NOTICE OF PUBLIC MEETING

Pursuant to Section 19.84, Wis. Stats., notice is hereby given to the public that the **Plan Commission** of the City of De Pere will meet on May 28, 2013 at 7:00 p.m. in the City Hall Council Chambers, Second Floor, City Hall, 335 South Broadway, De Pere, WI 54115.

Item #3: Review The Site Plan Application For A 39,060 Square Foot Building Expansion At Infinity Machine, 2249 American Boulevard. Applicant: Schuh Construction.

Item #4a: Review a Precise Implementation Plan (PIP) For Walgreens Located At The Northeast Corner of Broadway And Wisconsin. Applicant: Midland Development.

PROPOSED SITE PLAN

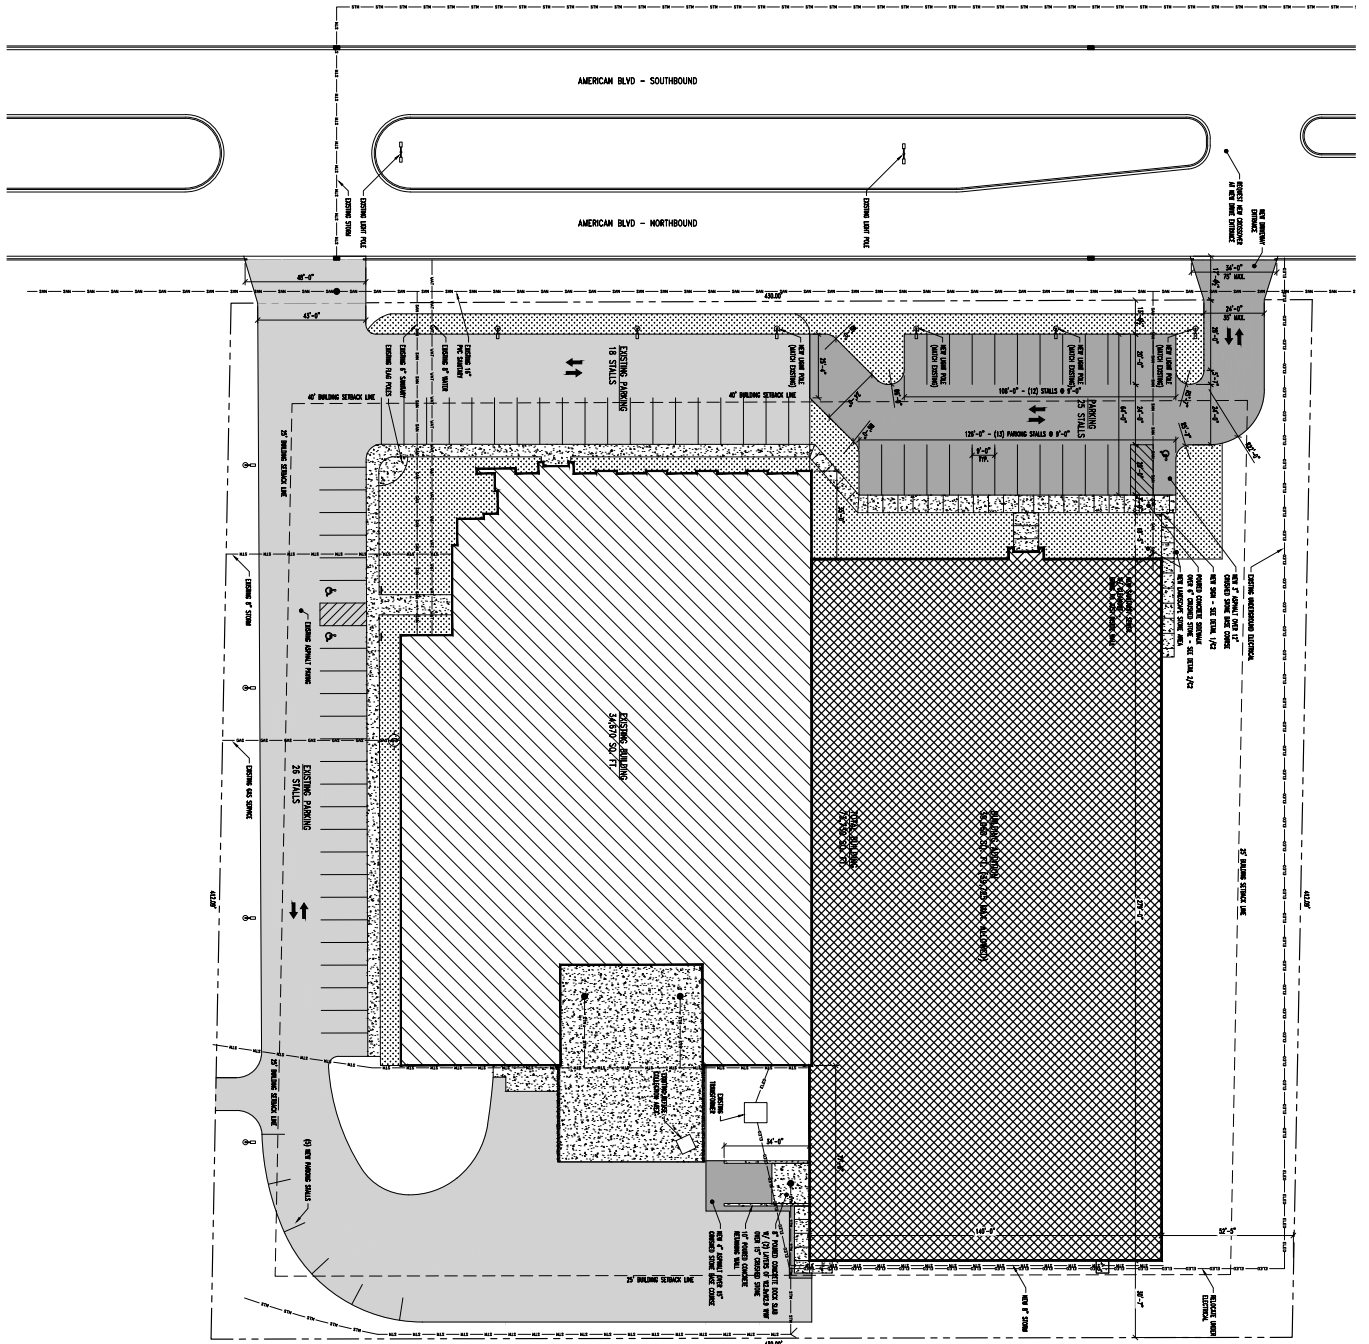
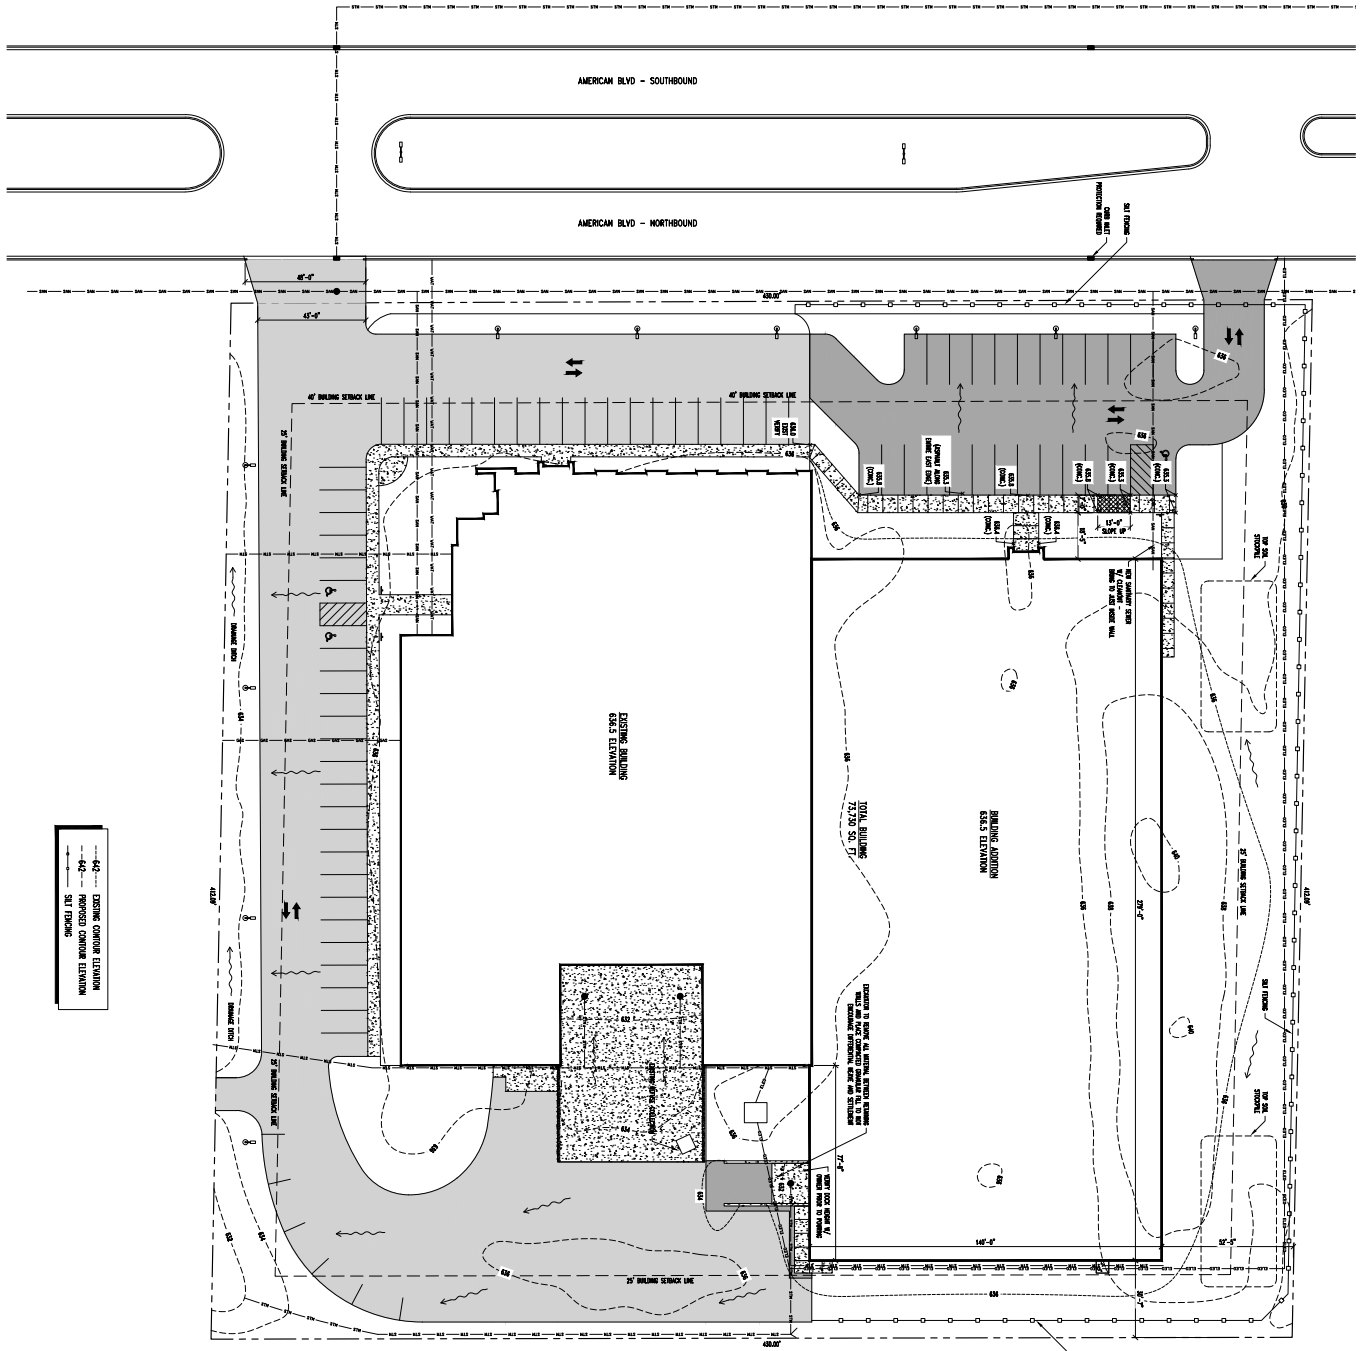
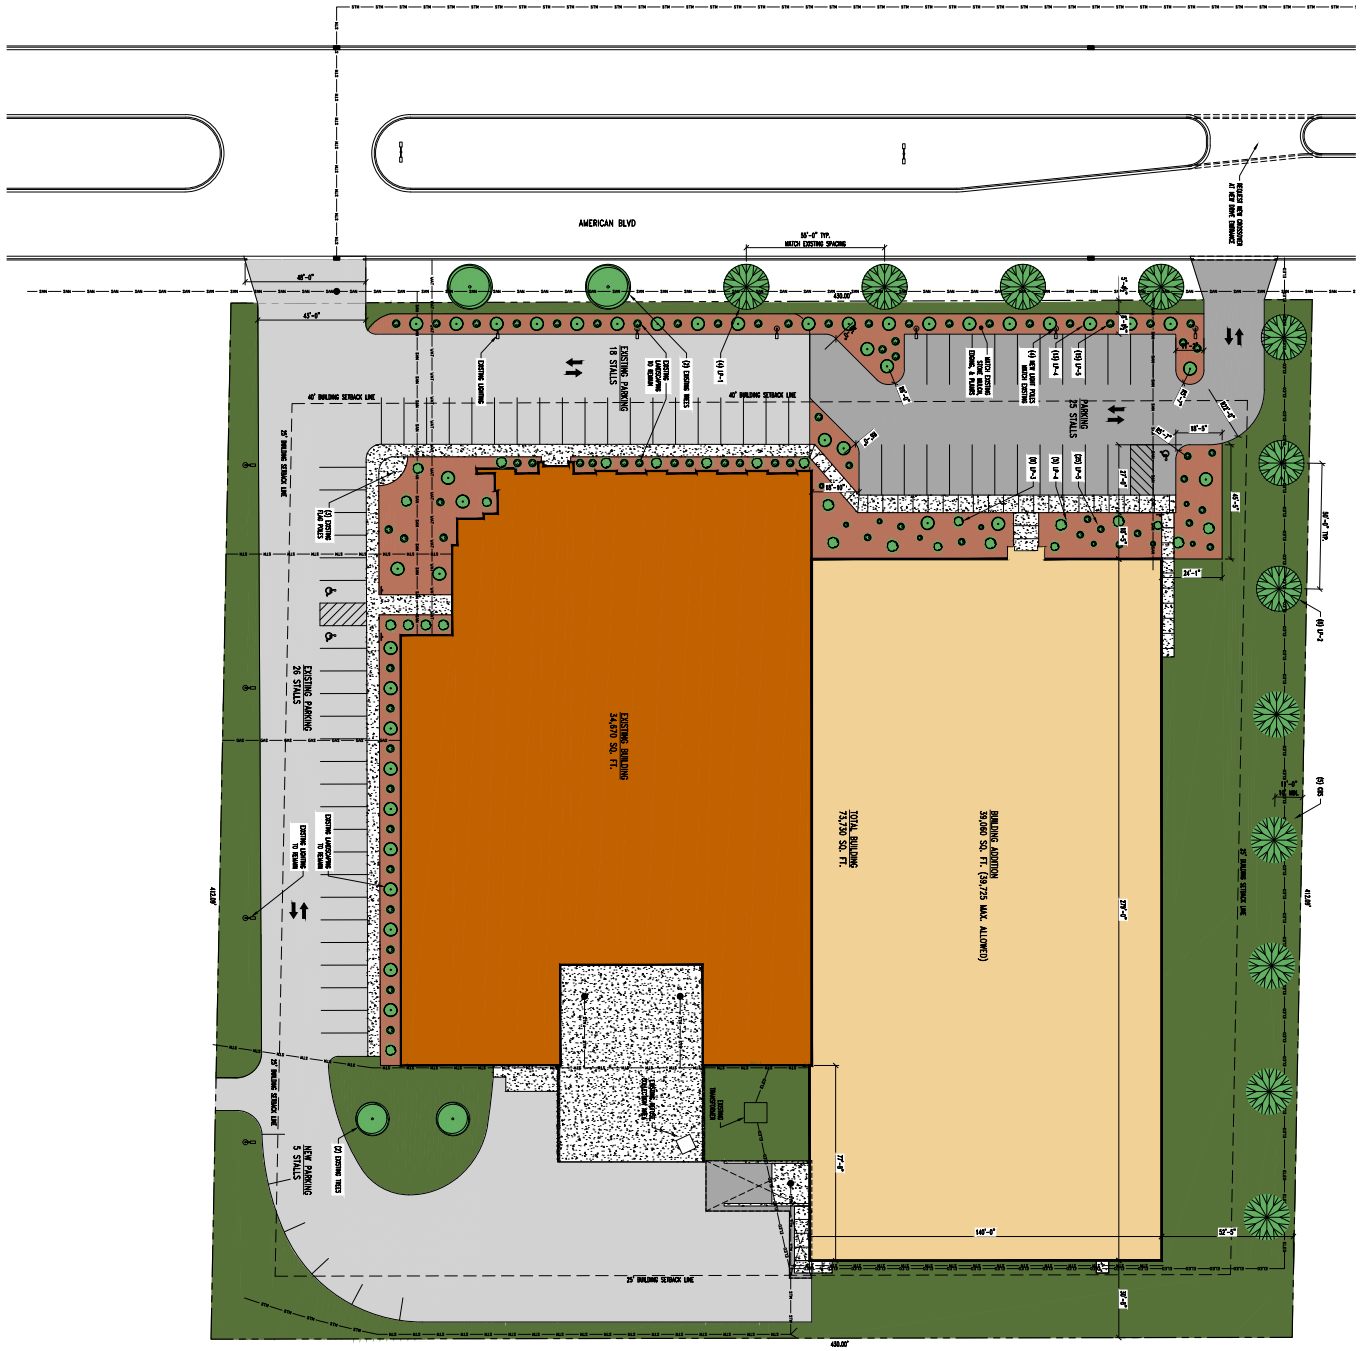
1. The existing sanitary main is 24" PVC, not 16" as shown on the plan. There is an existing 6" PVC sanitary sewer lateral centered on Lot 8, 10 feet north of the water lateral. Utilize this connection in place of the one shown on the plan. Show the size of the new lateral on the plan.	
Water Main

3. Storm water management will be provided by a City regional detention pond.	
4. Provide a storm water management plan for the site.	
5. Provide a tracking pad on the erosion control plan. Show the dimensions on the plan to verify the size can accommodate construction vehicle ingress and egress from the site.	
Traffic/Vehicle Access:

3. Existing driveway approaches within the right of way should be 6-inch concrete. Driveways for heavy trucks should be 8-inch.	
General:	
1. The plan provided is not scalable.	
Forestry & Parks	
Does the project meet the City Landscaping Regulations?	■ Yes <input type="checkbox"/> No <input type="checkbox"/> NA
<i>Required Actions:</i>

FLOOR PLAN
1/8" = 1'-0"

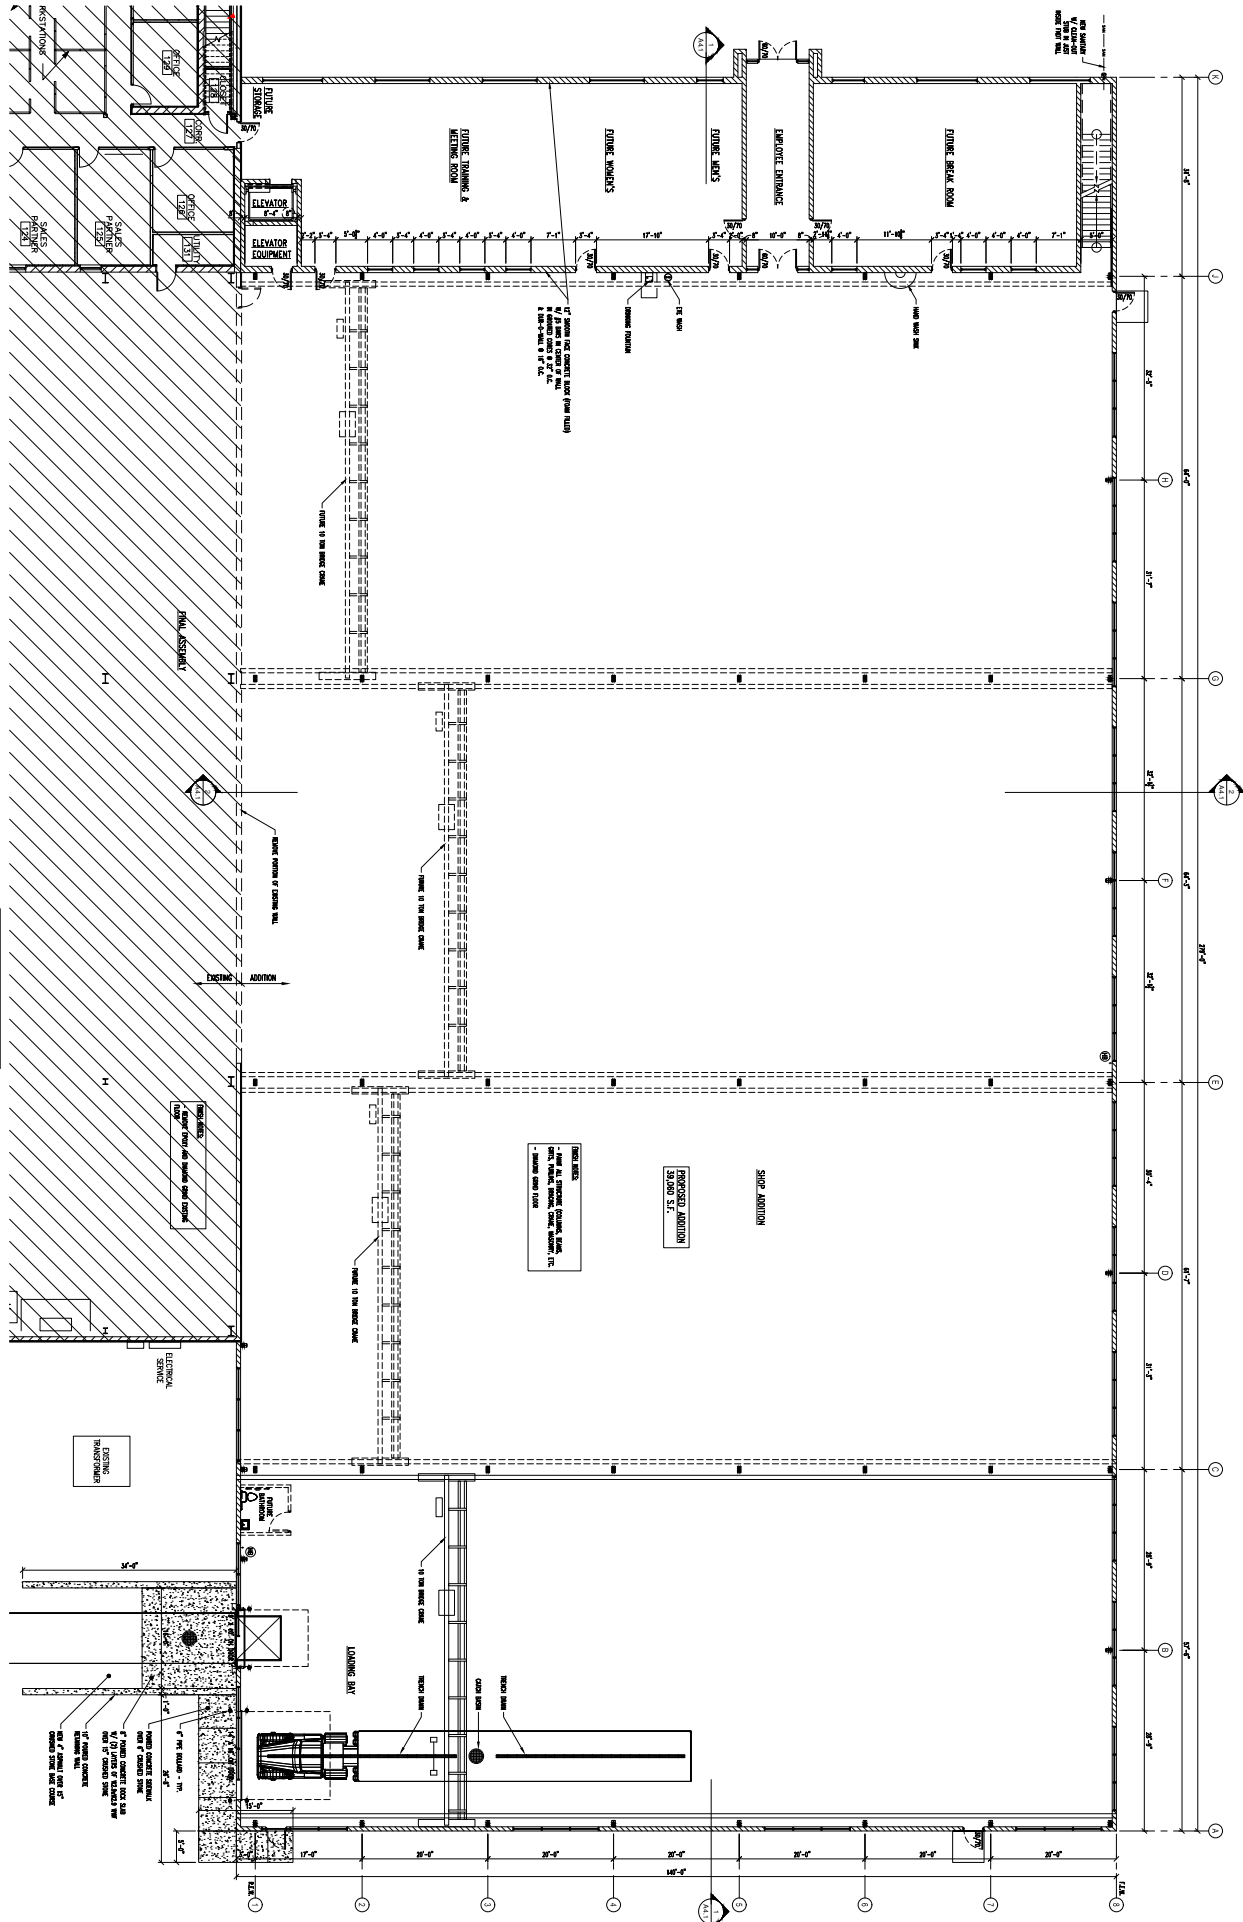
1. All planting, mulching, and staking should be in accordance with WDNR recommendations, and current proper practices. There are guidelines included on the Landscape Plan, but they should be altered to meet the proper guidelines set by the WDNR.

2. All plant material, and beds should have a follow-up schedule for maintenance, and replacement. It is essential that this schedule be established to ensure that the plants are maintained for health, and any compromised plants are to be replaced in a timely manner.

3. A preservation, and protection plan for existing vegetation, and trees, including City owned trees, and shrubs, should be included in the plans when applicable.	
<i>Recommendation</i>

4. It appears the plantings will perform well in our environment. The plan is, however, lacking in color. It would be a great addition to add other shrubs and perennials that provide seasonal color in all planting areas.
